Burlington Development Review Board

Development Review Board

Tuesday, September 3, 2024, 5:00 PM

TO: Development Review Board
FROM: Scott Gustin
DATE: September 3, 2024
RE: ZP-21-323; 59-61 Spruce Street

1 PROPOSED FLOOR PLAN
1/4 in = 1 ft

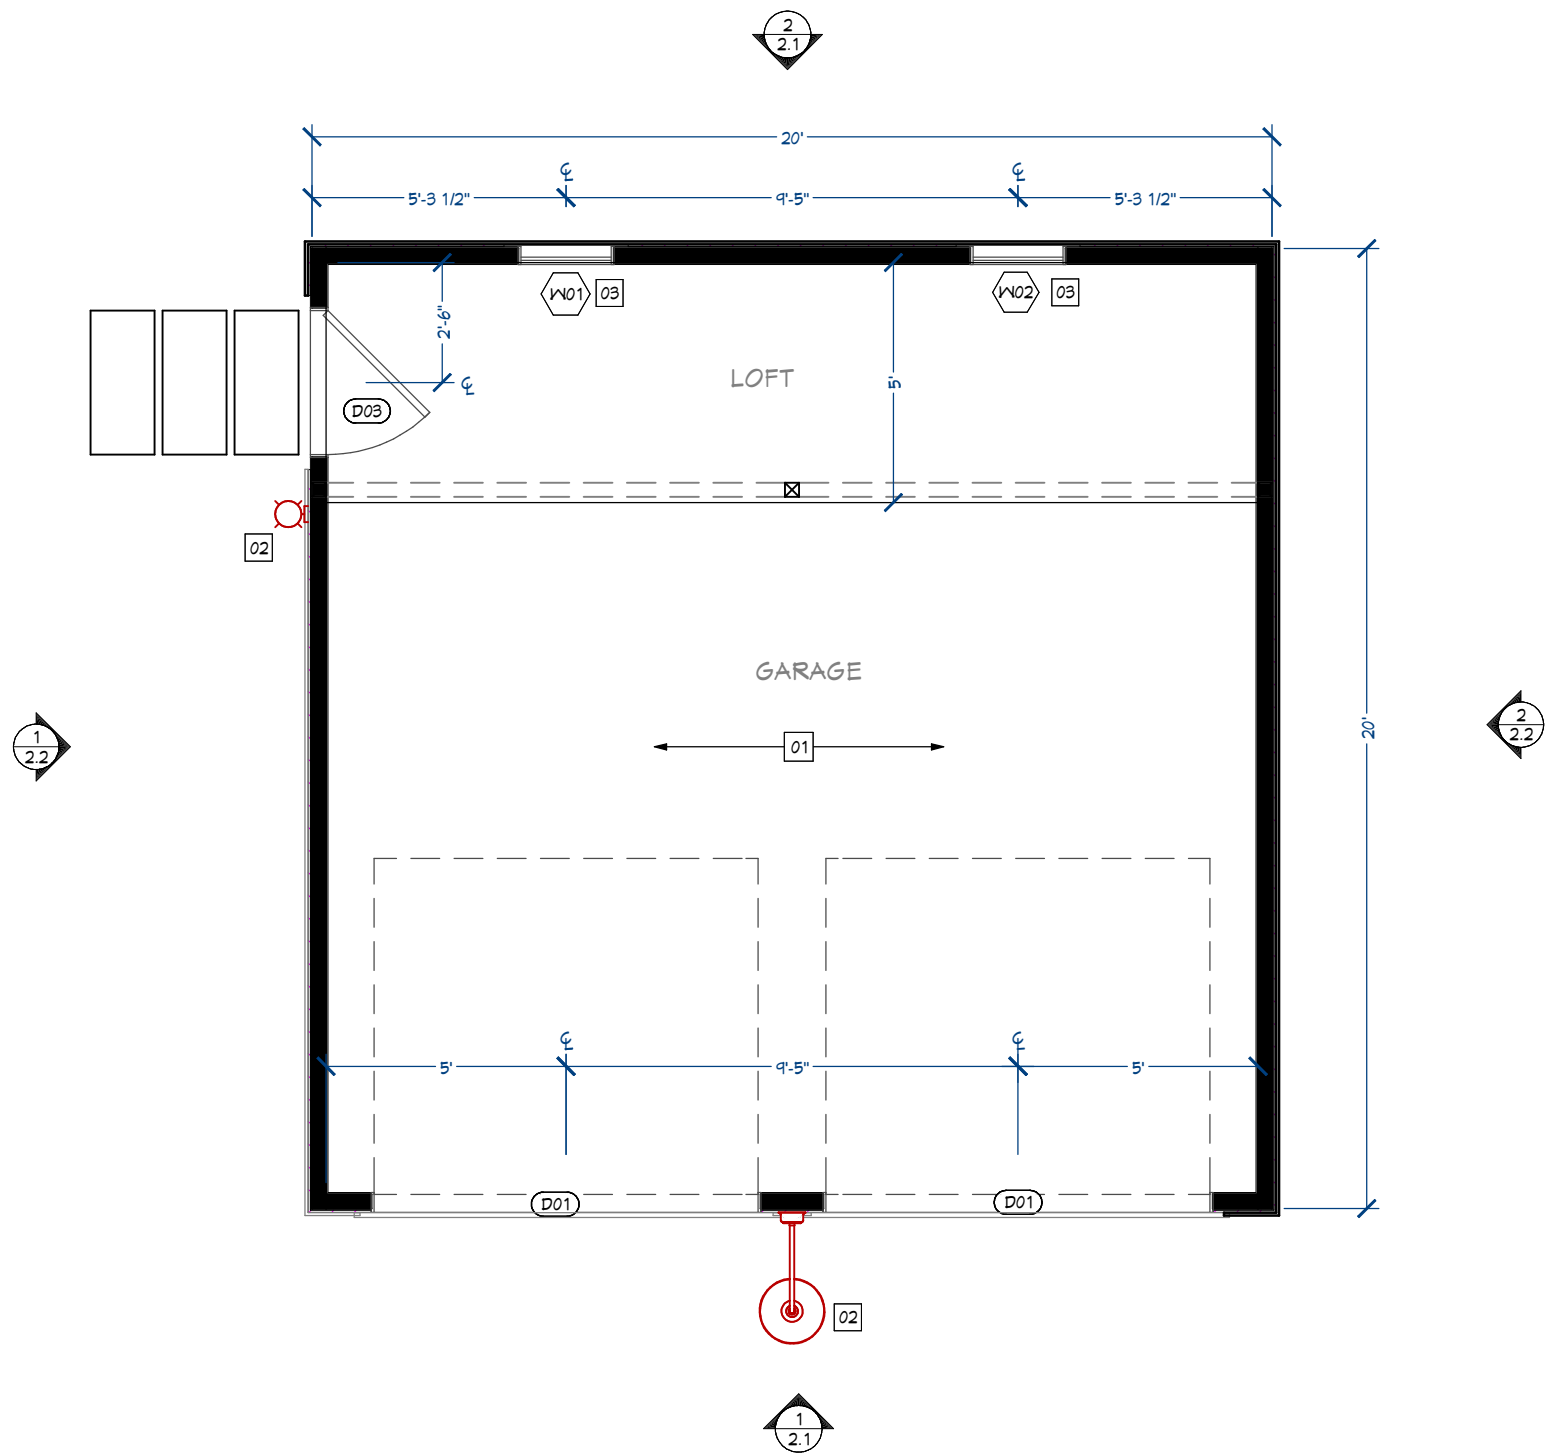
The front overhead doors and side entry will be illuminated. Lighting fixture locations are depicted on the project plans and include an acceptable residential-style light fixture. The cut sheet shows acceptable illumination levels. **(Affirmative finding)**

Reference: **SECORD Mobility Framework**

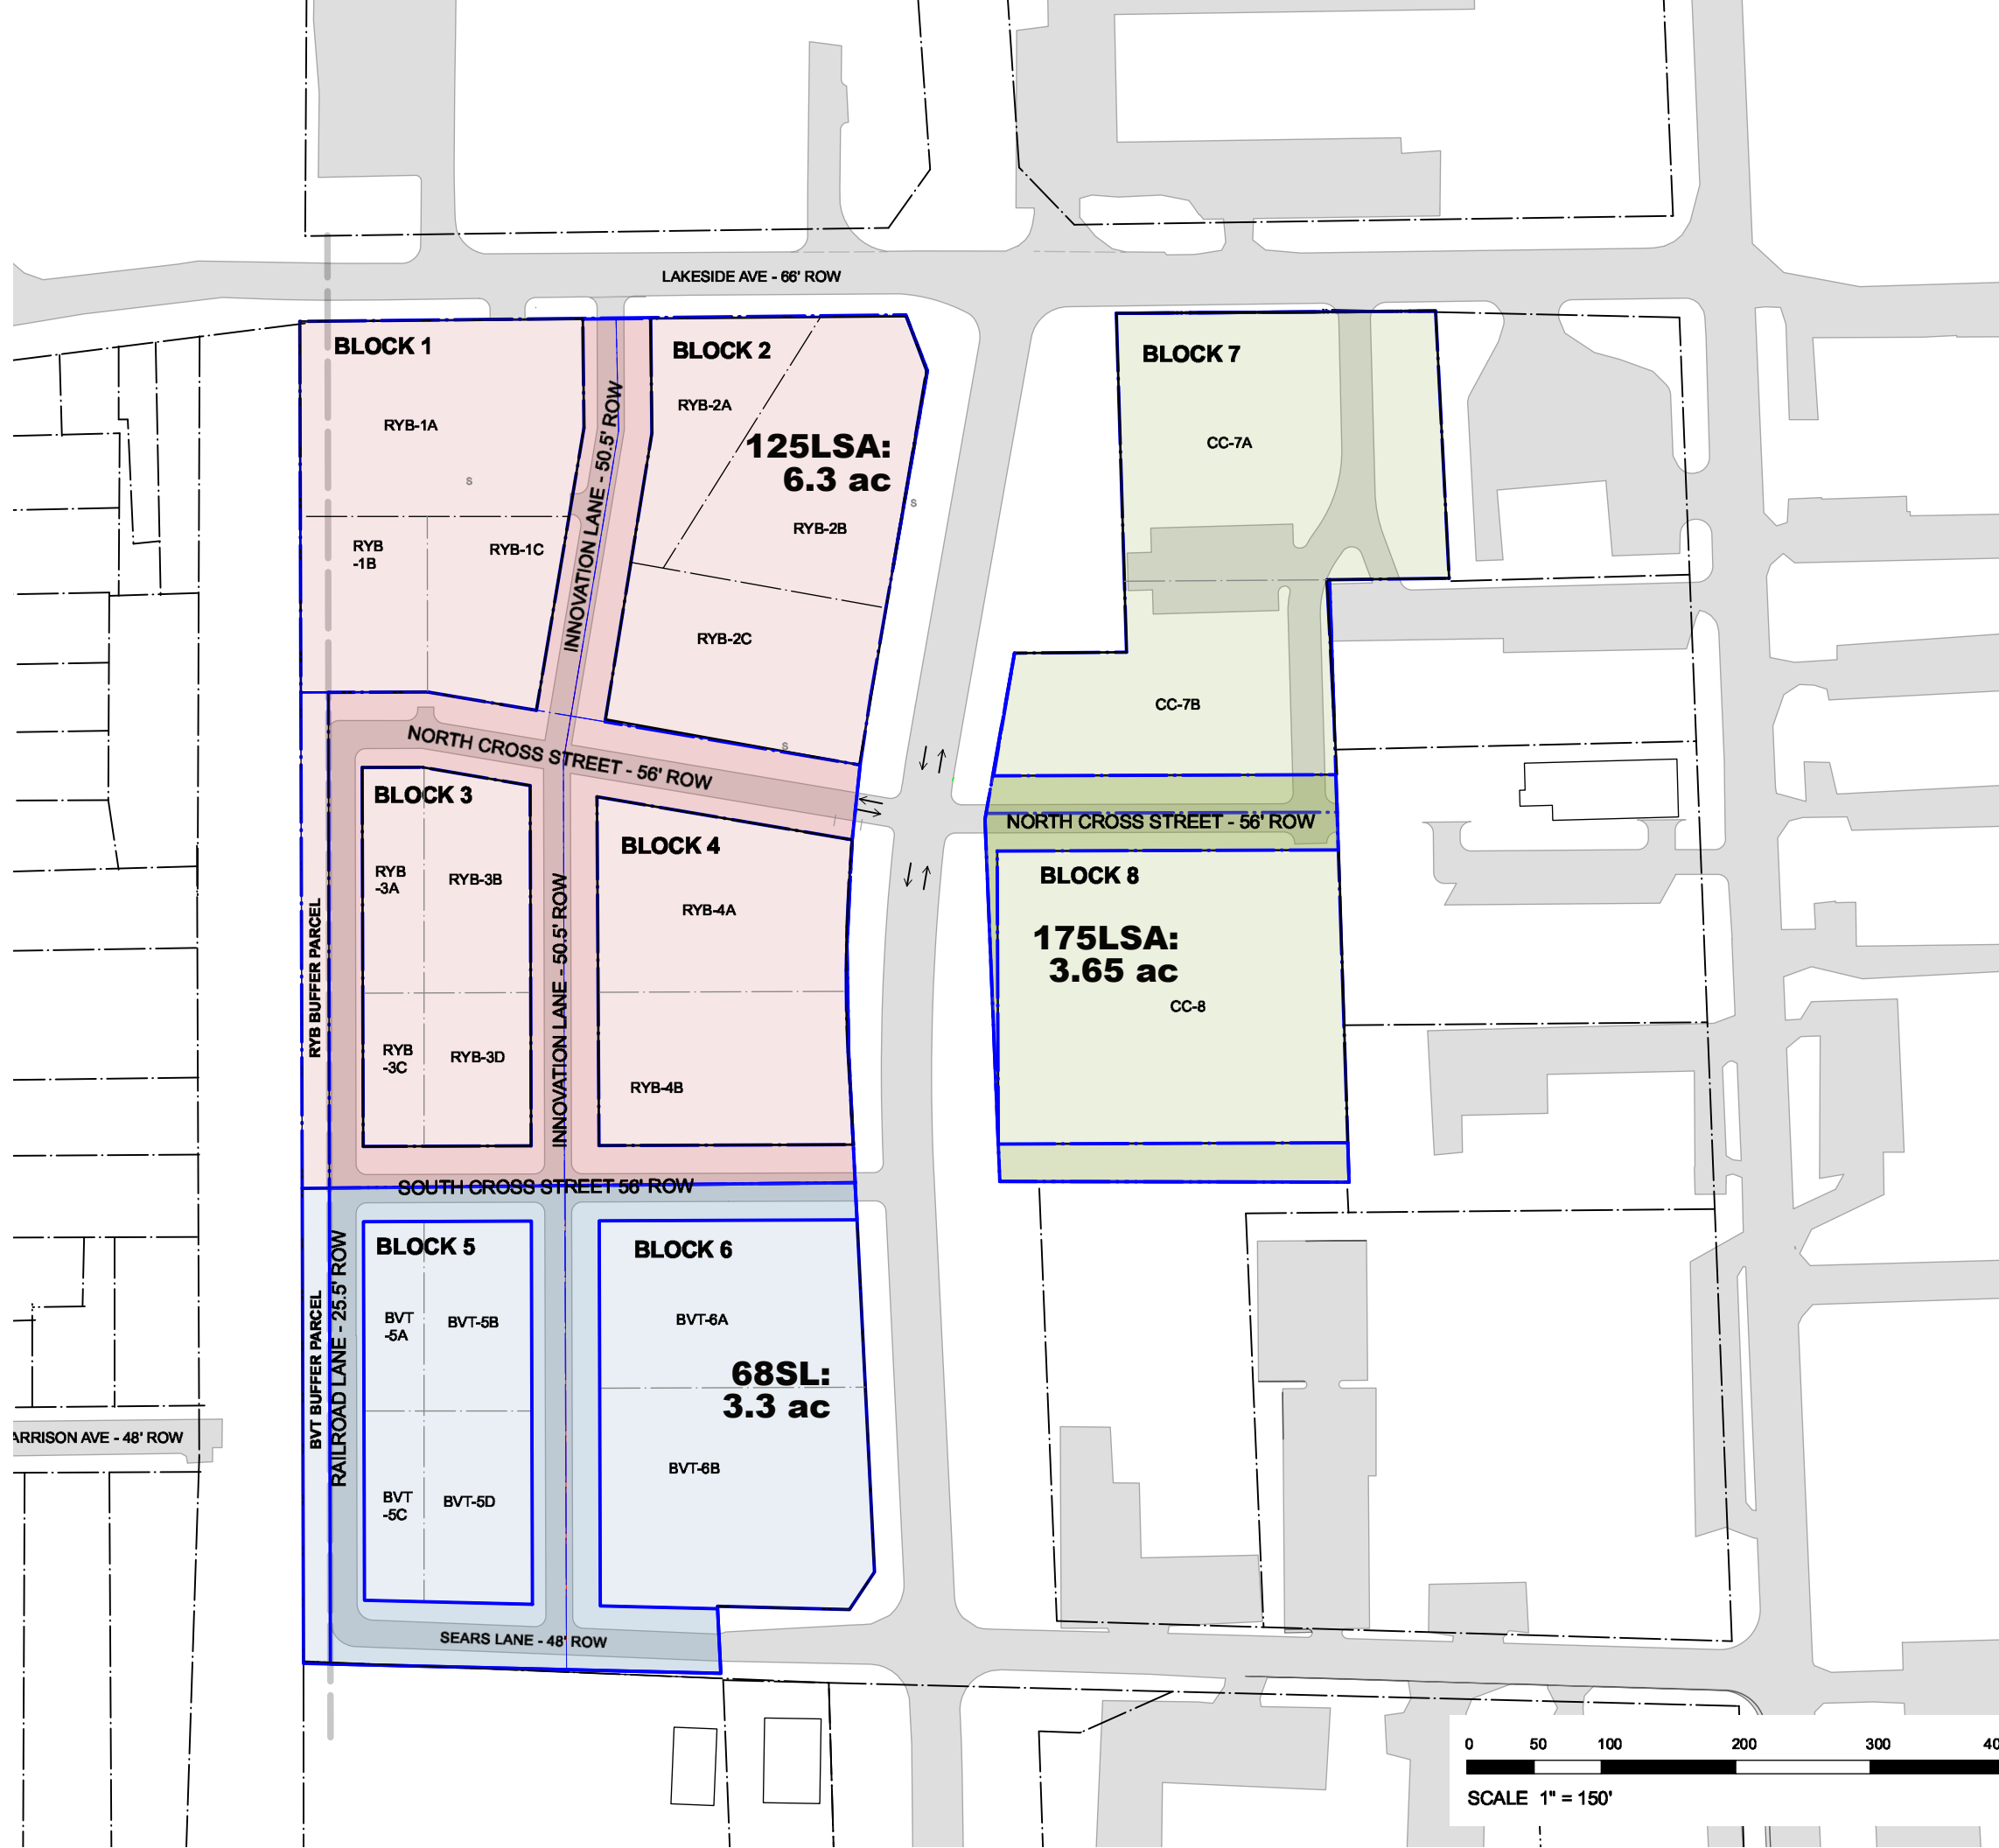
The sketch plans do not contain a traffic analysis. One will be required upon permit application. The sketch plans do contain a memo from Stantec comprehensively outlining what the traffic study will include. This memo has been provided to the Department of Public Works for review and comment.

CONCEPTUAL
SITE TEST FIT

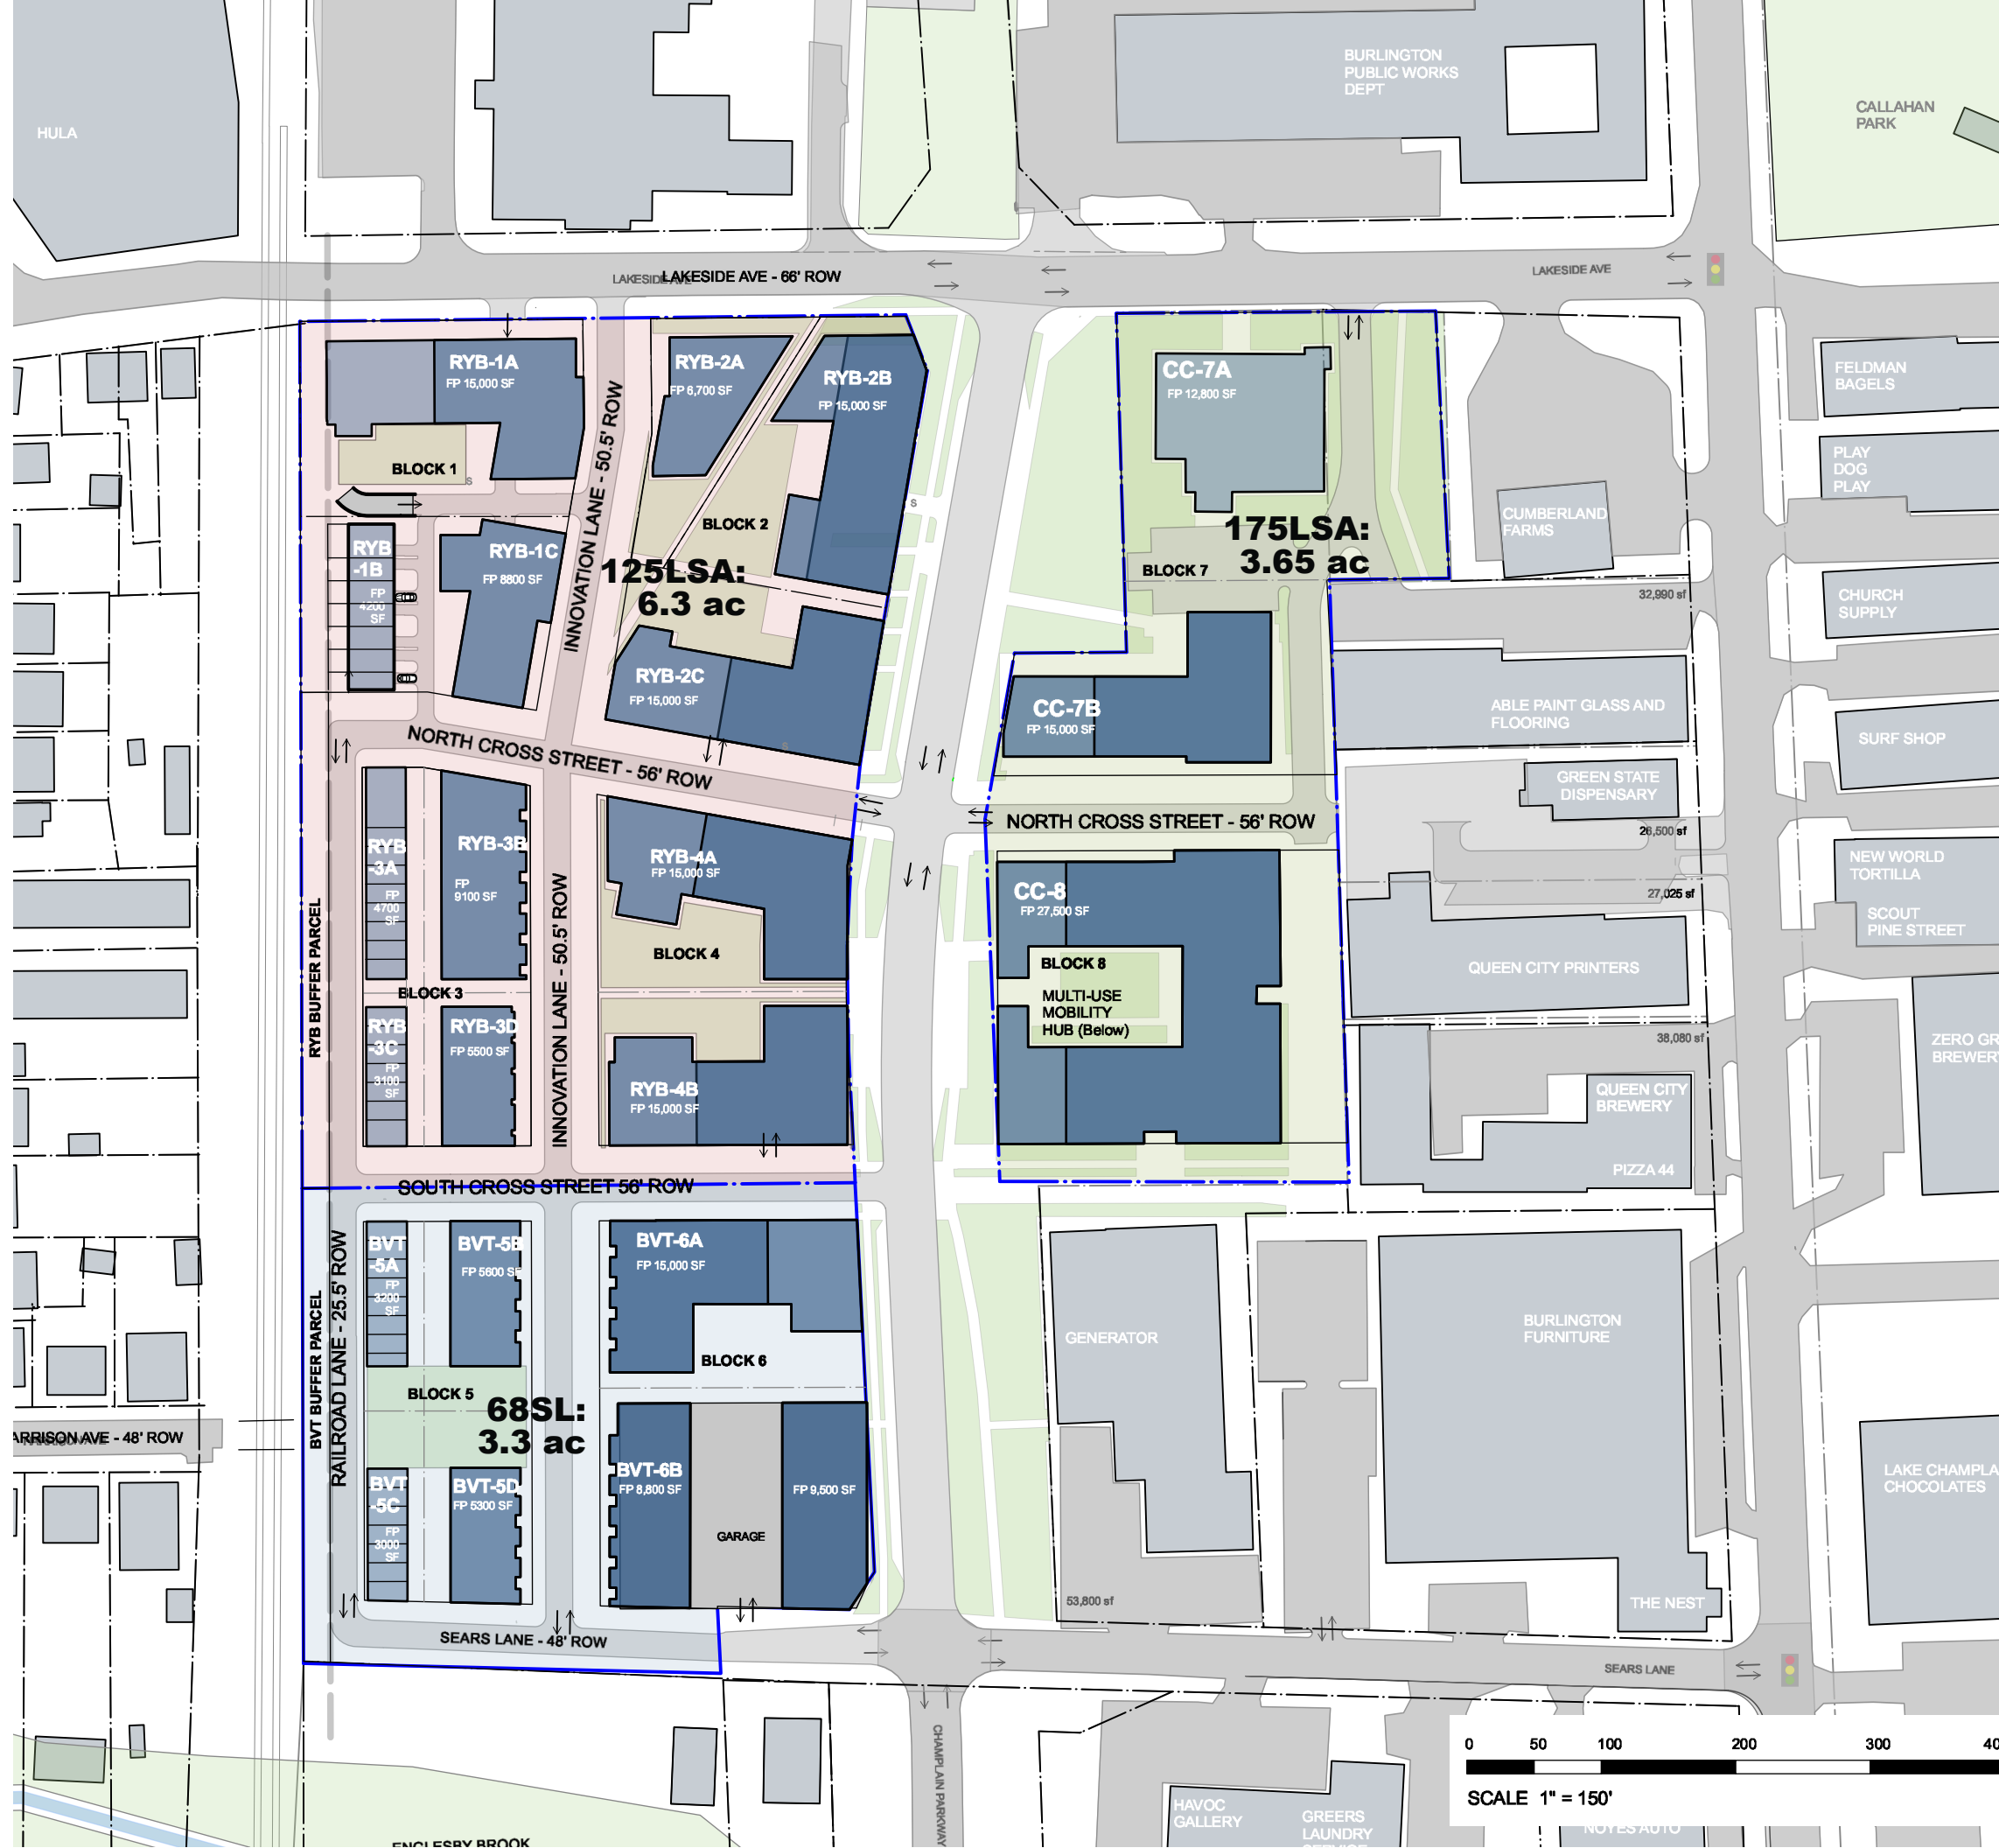
The sketch plans lack sufficient detail to determine full compliance with this criterion. Additional details will be required upon application. Generally, the proposed building layouts appear to be consistent with the lot frontage requirements of Table 4.5.6-2. The sketch plans depict a combination of “active uses only,” “all uses, except residential,” and “all uses, including residential” within potential building footprints. This delineation is aimed at the 80% vs. 20% non-residential building frontage along primary vs. secondary frontages, respectively. Permit application plans will need to specify primary and secondary frontages, area and frontage of non-residential ground floor uses, and entry details.

Additional detail is needed upon permit application to determine compliance with this criterion. The sketch plans depict building footprints that include residential and non-residential uses and building placement within maximum and minimum front setbacks and frontage lengths as required.

The sketch plans depict little in the way of parking and circulation details. A garage is noted in the southeast corner of the development. Application plans must include parking details as to location, type (surface vs. garage), dimensions, and circulation patterns. Surface parking areas with 15 or more spaces must include shade trees at a ratio of 1 shade tree for every 5 parking spaces. The objective is 30% shading of surface parking areas.
